# IEEE *Draft* P802.3cg/D3.0 Delimiter Randomization

Proposal relating to comment i-284

MICK MCCARTHY, ANALOG DEVICES  
STEFFEN GRABER, PEPPERL+FUCHS

22 MAY 2019

# SSD4, ESD4 and ESD\_ERR4

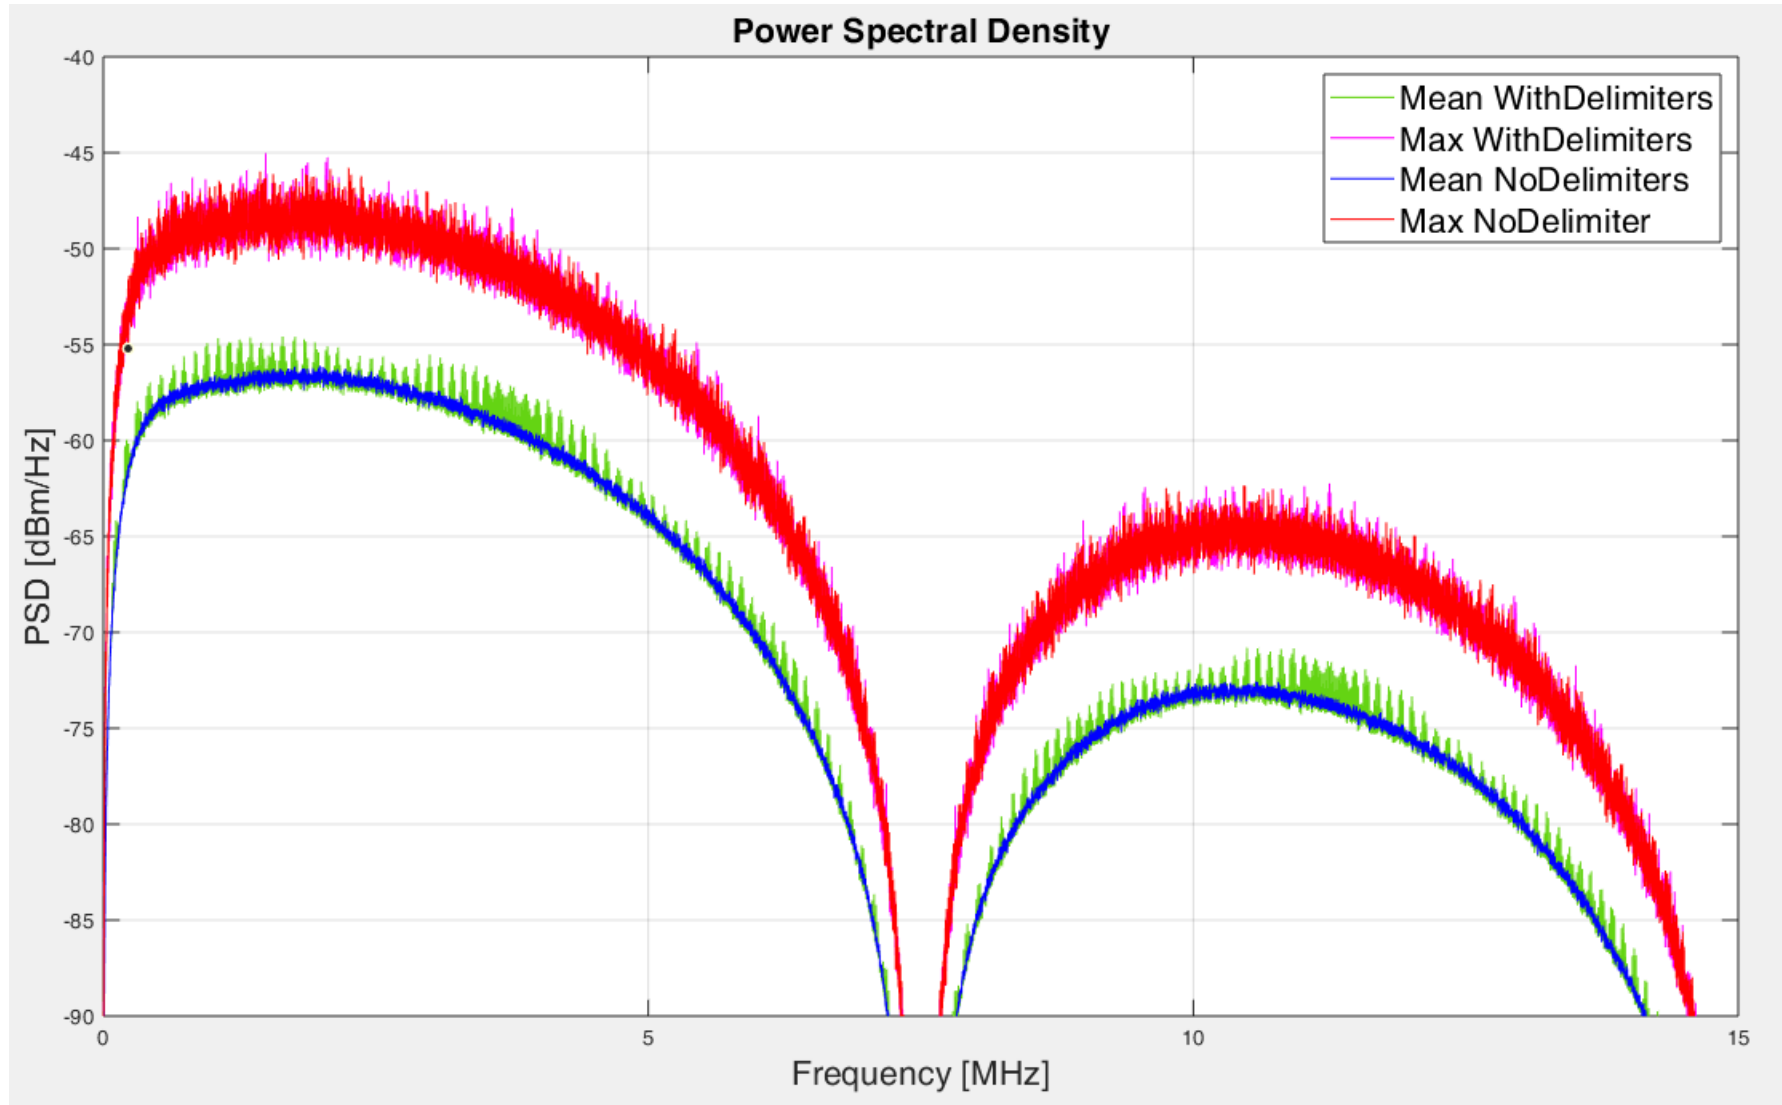
- ▶ In IEEE P802.3cg™/D3.0 the frame delimiters are defined in Table 146-3 as follows:

- ▶ Note that the delimiters are constant
  - When frames of fixed length are continuously transmitted using a fixed interframe gap harmonics appear in the transmitted power spectrum
  - Adaptive processes may align with the constant ternary symbols of the delimiters potentially causing filter coefficients to become misadjusted

# Proposed Delimiter Encoding

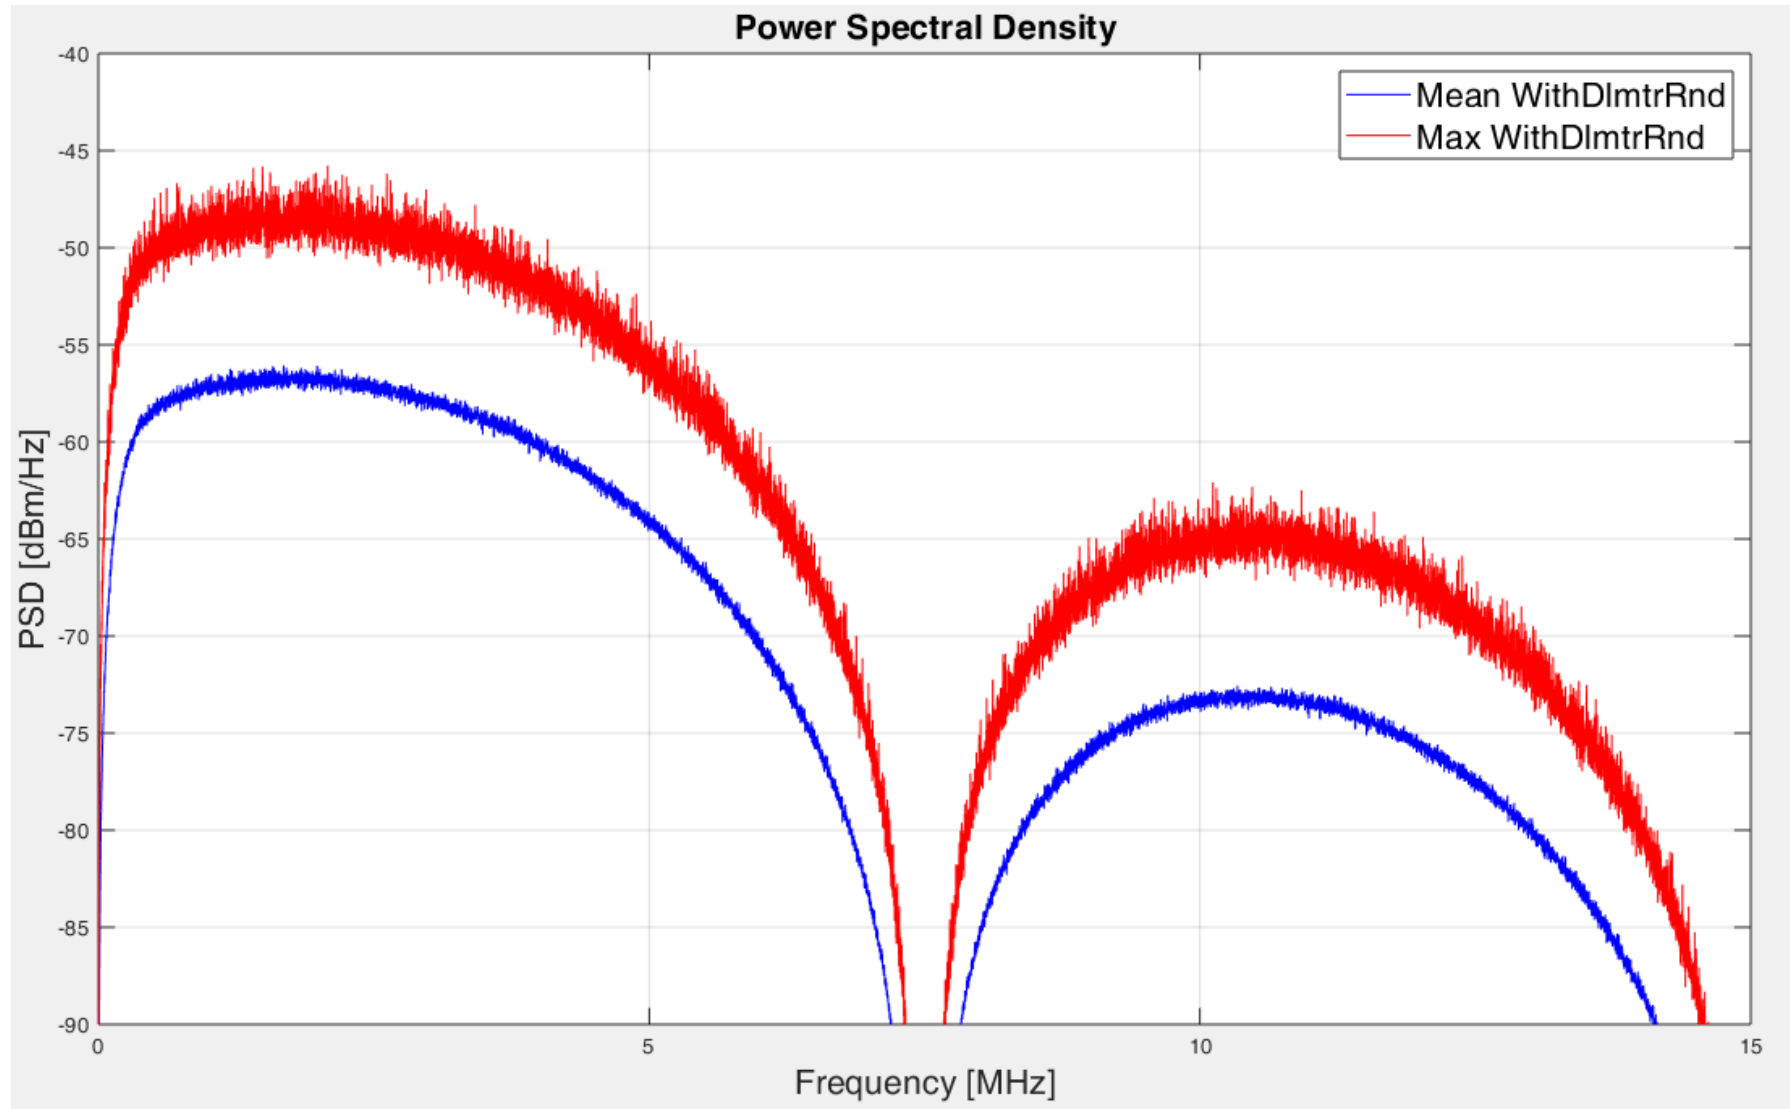
- ▶ Propose to replace Table 146-3 with the following:

- ▶ Ternary triplets as in current draft when  $Sy_{n-1}[4] = 0$
- ▶ Ternary triplets negated when  $Sy_{n-1}[4] = 1$

Delimiter	$(TA_n, TB_n, TC_n)$
$Sy_{n-1}[4] = 0$	SSD4	(1, 1, -1)
	ESD4	(1, -1, 1)
	ESD_ERR4	(-1, 1, 1)
$Sy_{n-1}[4] = 1$	SSD4	(-1, -1, 1)
	ESD4	(-1, 1, -1)
	ESD_ERR4	(1, -1, -1)

# Detailed Changes to Figure 146-5 - PCS Transmit State Diagram

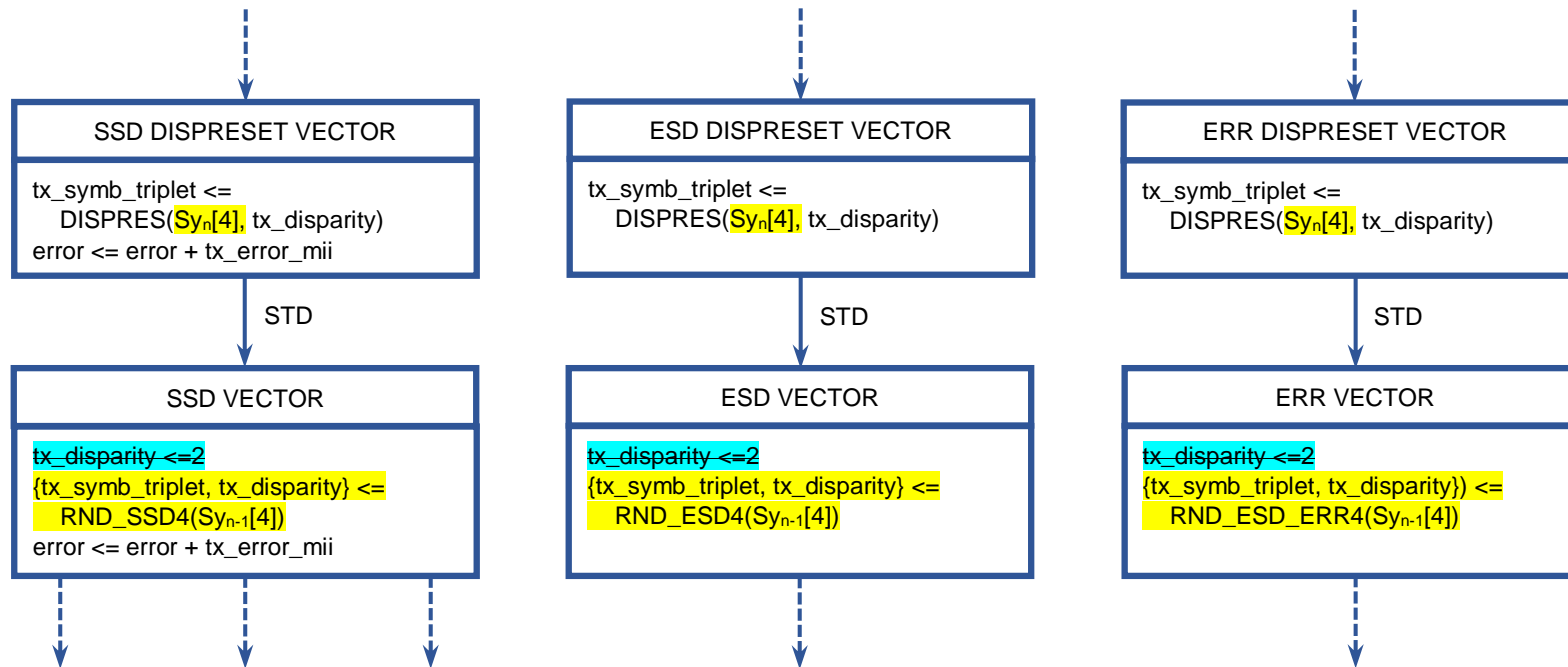
- ▶ Dashed arrows come from and go to unchanged parts of the state diagram
- ▶ Modified state diagram uses the modified DISPRES function and the new RND\_SSD4, RND\_ESD4 and RND\_ESD\_ERR4 functions

# Detailed Changes to Figure 146-8 - PCS Receive State Diagram (part a)

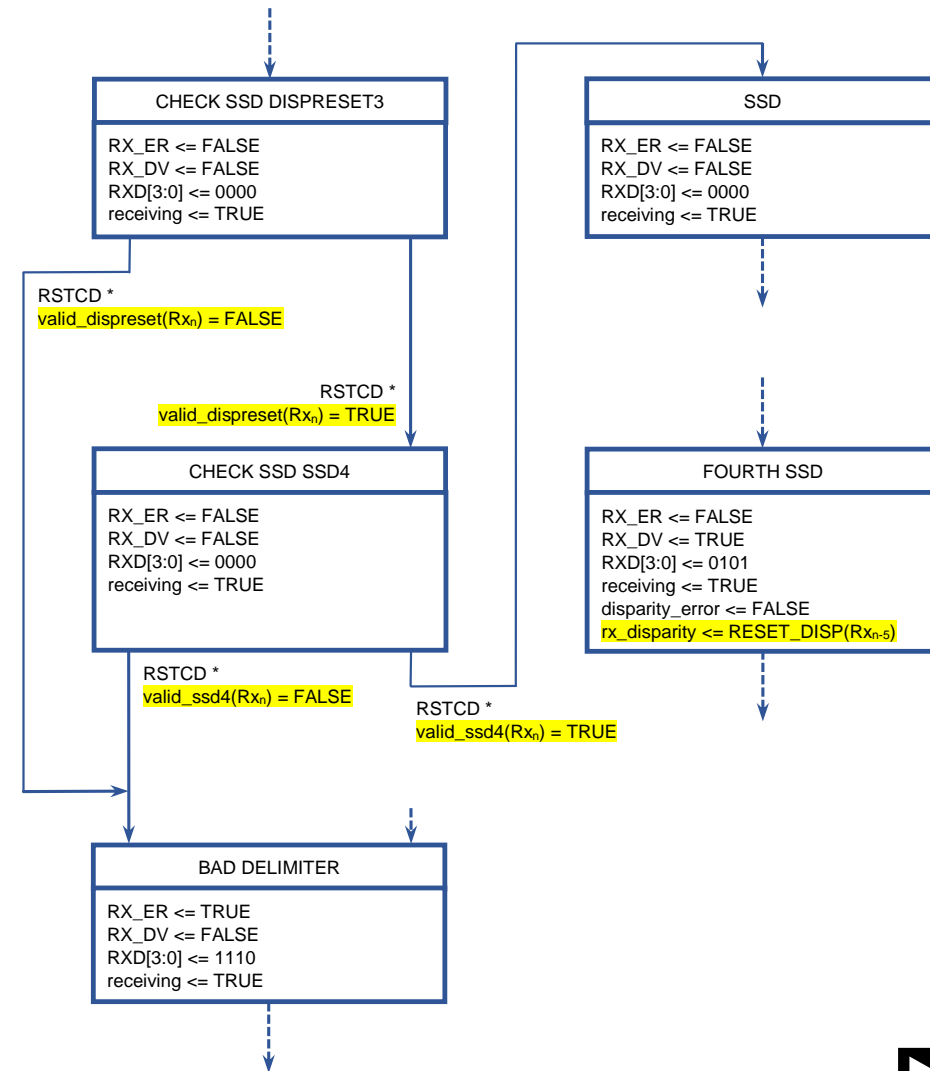
- ▶ Dashed arrows come from and go to unchanged parts of the state diagram
- ▶ Calls to function `valid_dispreset` modified to pass  $Rx_n$  as an argument
- ▶ State diagram modified to use the new `valid_ssd4` and `RESET_DISP` functions
- ▶ Checking of Boolean return values modified to follow convention

# Detailed Changes to Figure 146-9 - PCS Receive State Diagram (part b)

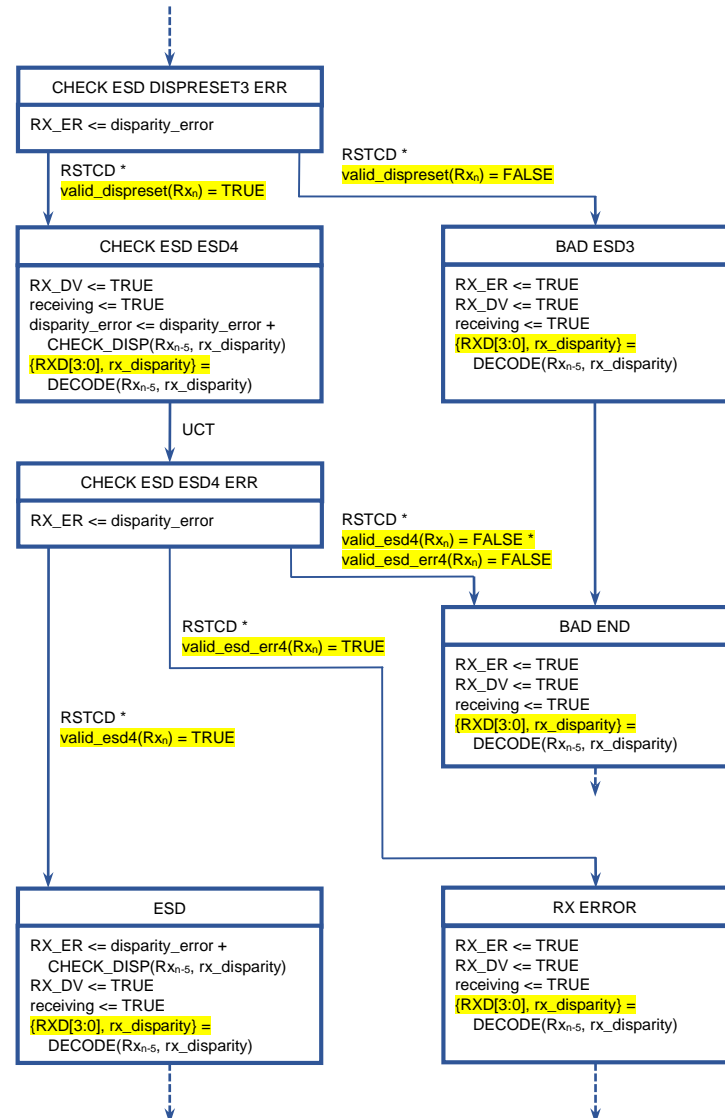
- ▶ Calls to function `valid_dispreset` modified to pass  $Rx_n$  as an argument
- ▶ State diagram modified to use the new `valid_esd4` and `valid_esd_err4` functions
- ▶ Checking of Boolean return values modified to follow convention
- ▶ DECODE function calls modified to explicitly show assignment to variables
